**DEVELOPMENT PLAN REVIEW APPLICATION
PLANNING & DEVELOPMENT SERVICES**

Project Name: 238 University

238 University Ave
DB-16-00038
Major Development Plan

Plot Date: 5/17/2016 12:08:33 PM Username: jsutton Layout Name: C2.01
Folder Path: V:\Projects\2015\15-195 004 - 238 W University Avenue\Design\CAD\Plans
Filename: 15-195 004 Site Plan.dwg

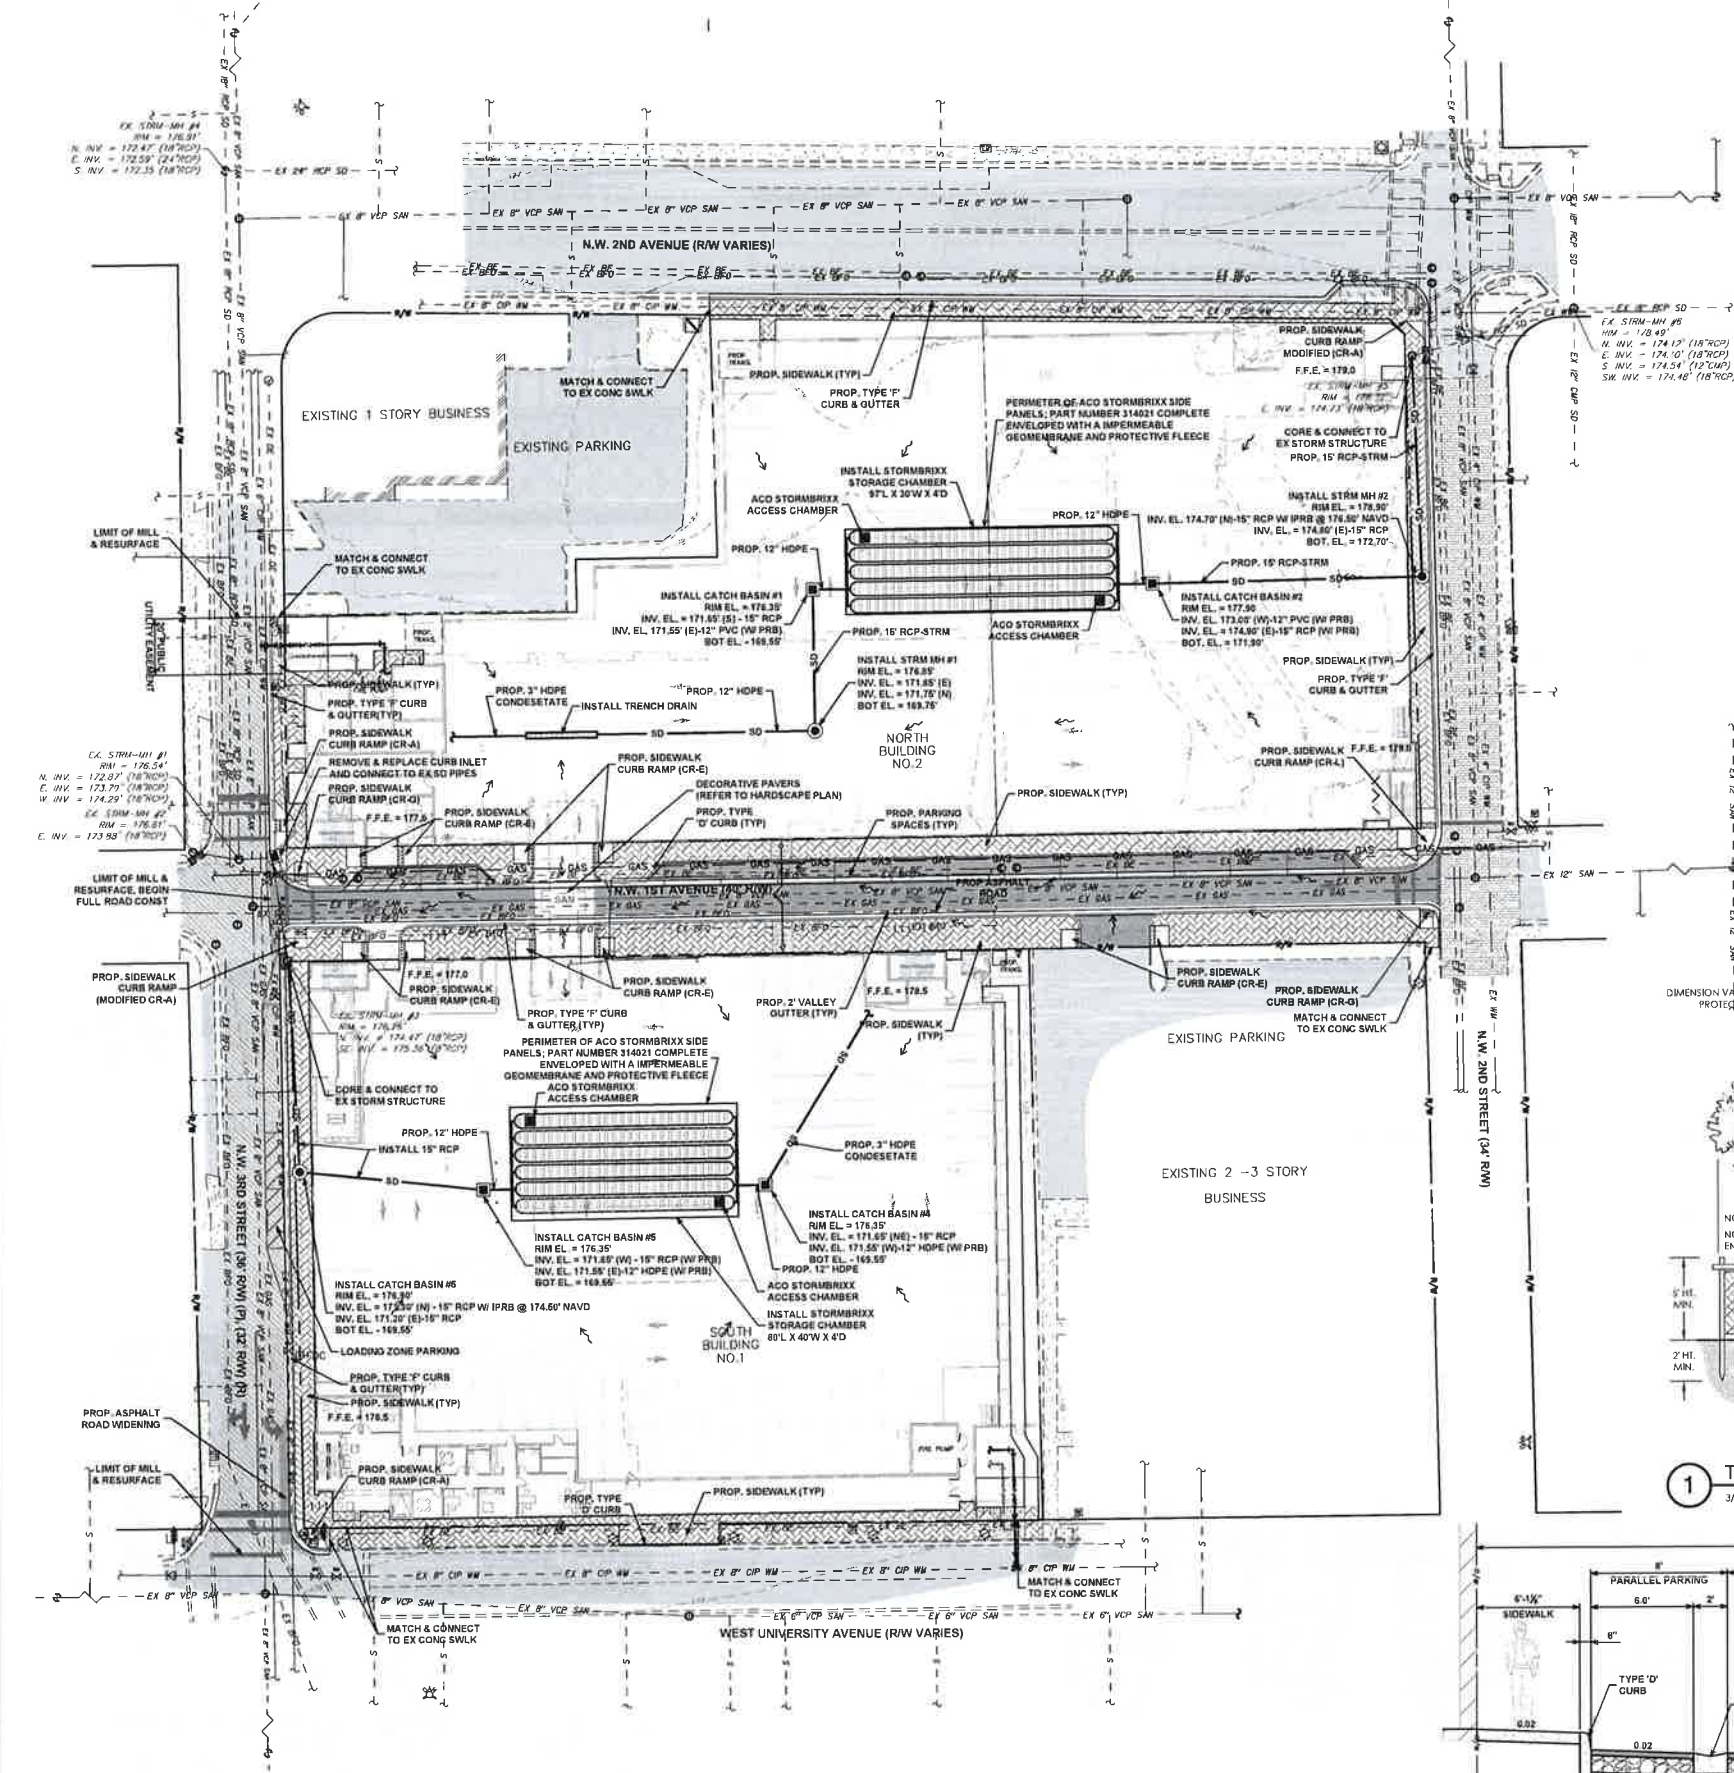
8. Please add a note near the trip generation table on sheet C2.01 indicating that this development is within Zone A of the Transportation Mobility Program Area will comply with Policies 10.1.4 and 10.1.14 of the Transportation Mobility Element.

Response: A note will be provided near the trip generation table on sheet C2.01 indicating that this development is within Zone A of the Transportation Mobility Program Area will comply with Policies 10.1.4 and 10.1.14 of the Transportation Mobility Element

PAVING AND DRAINAGE PLAN

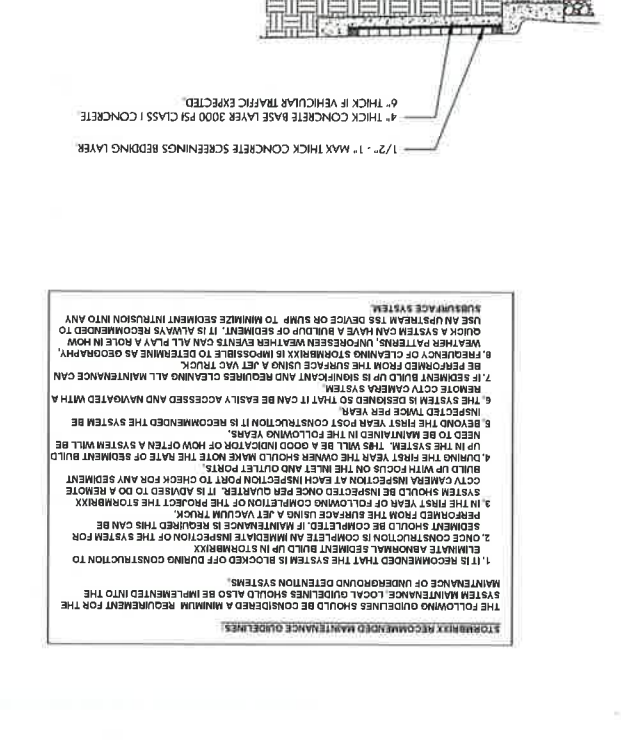
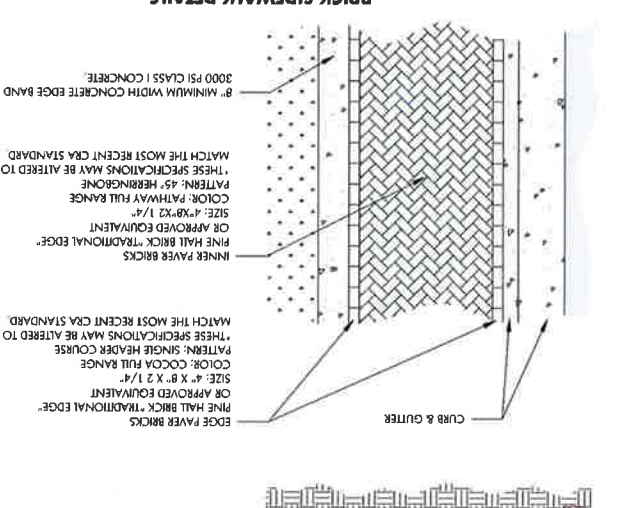
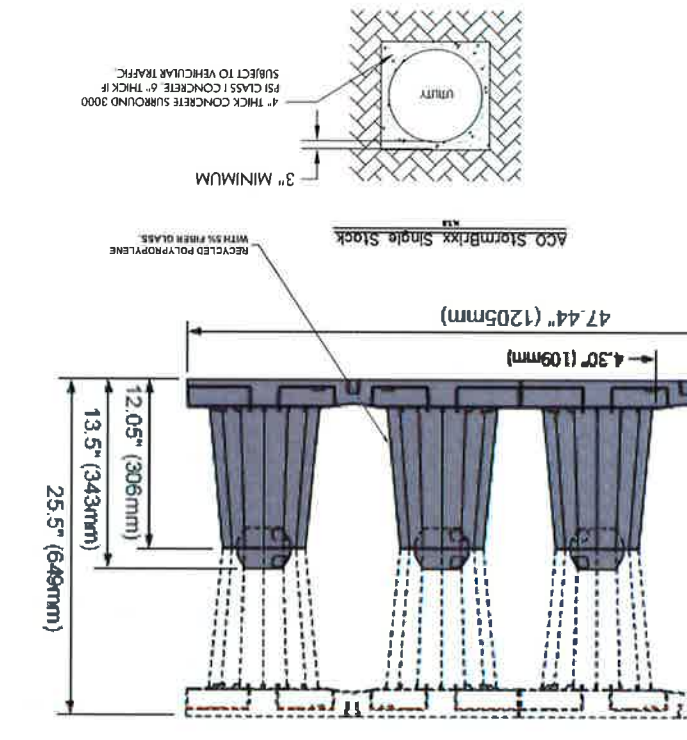
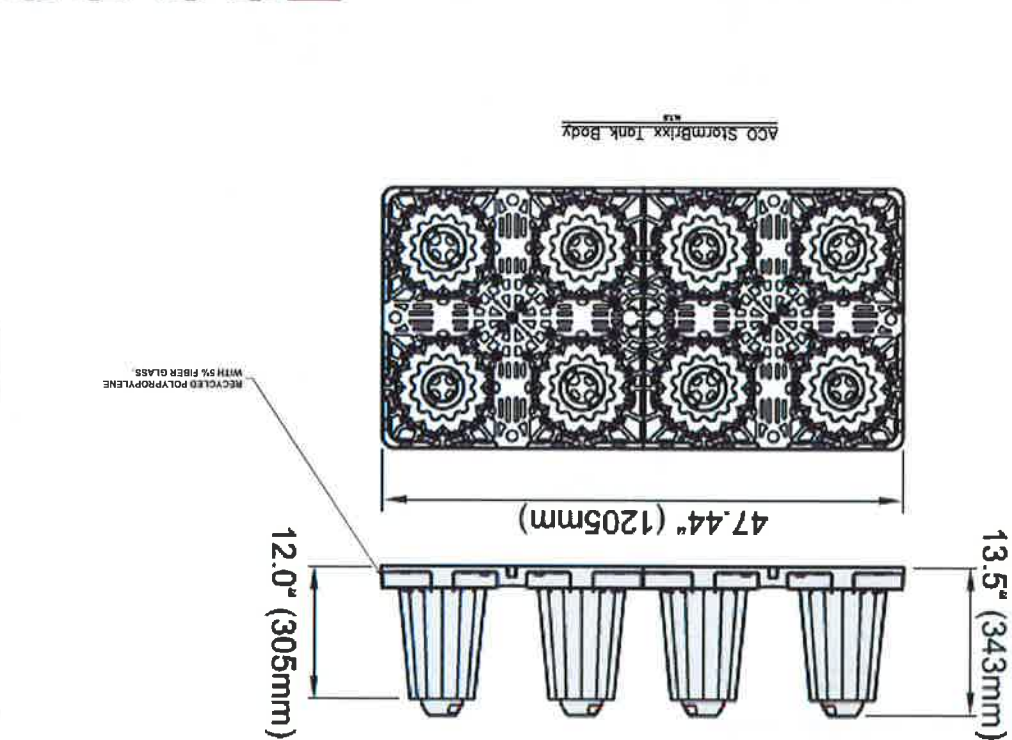
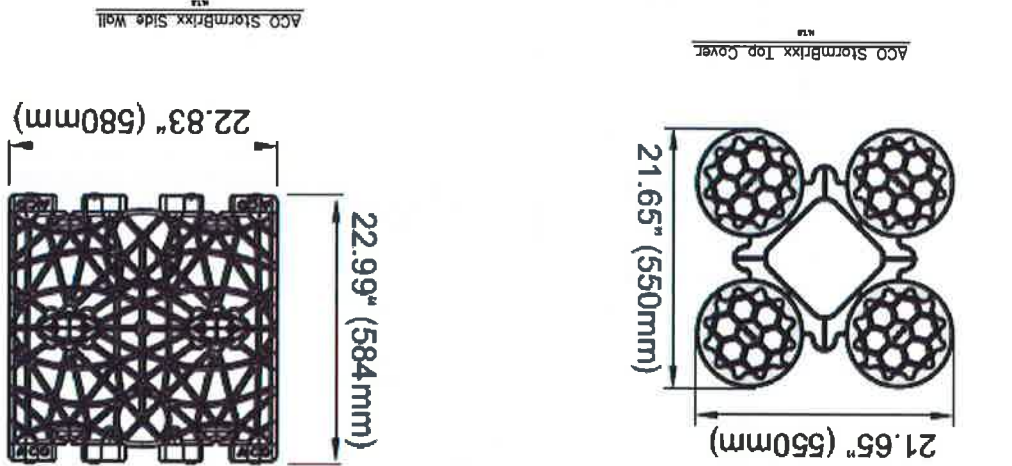
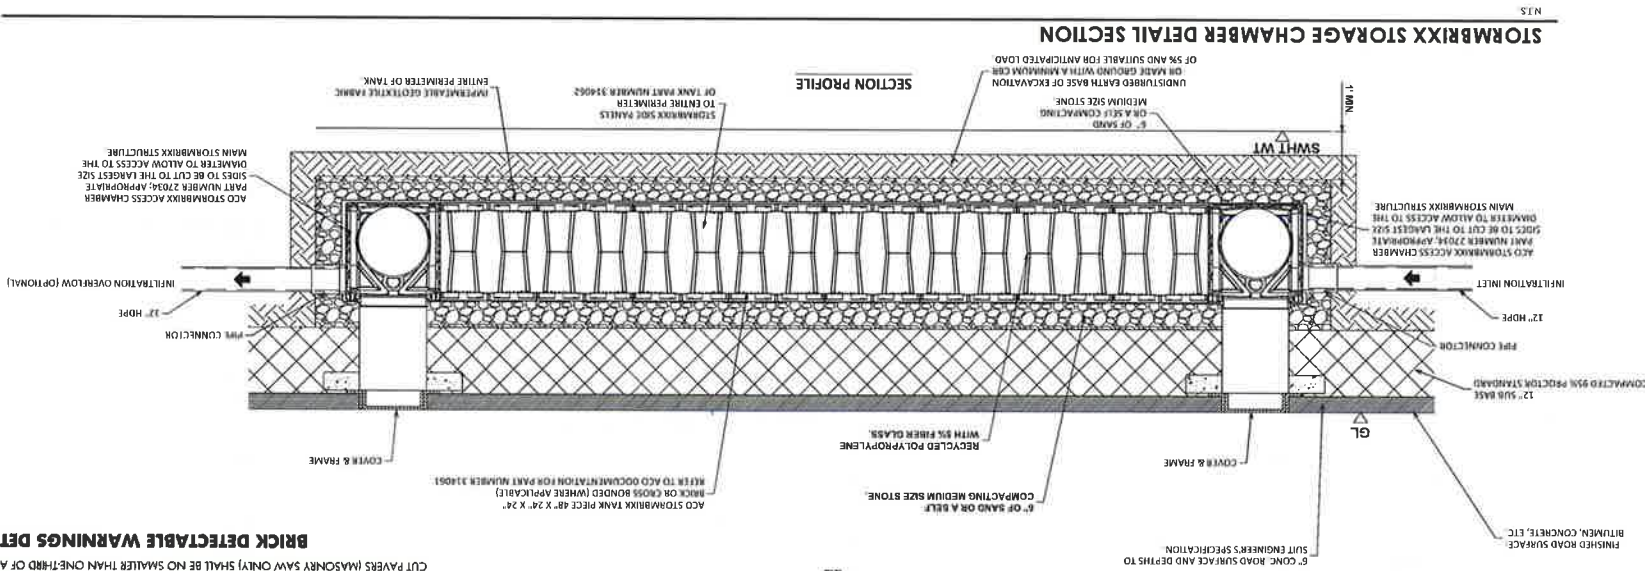
3 - Sheet C3.02, Stormbrixx Storage Chamber Detail Section calls out "impermeable geotextile fabric entire perimeter of tank" and is pointing to the bottom of the facility. The depiction of the system provided in the stormwater report indicates that this would be utilized in a detention system. This is a proposed retention system.
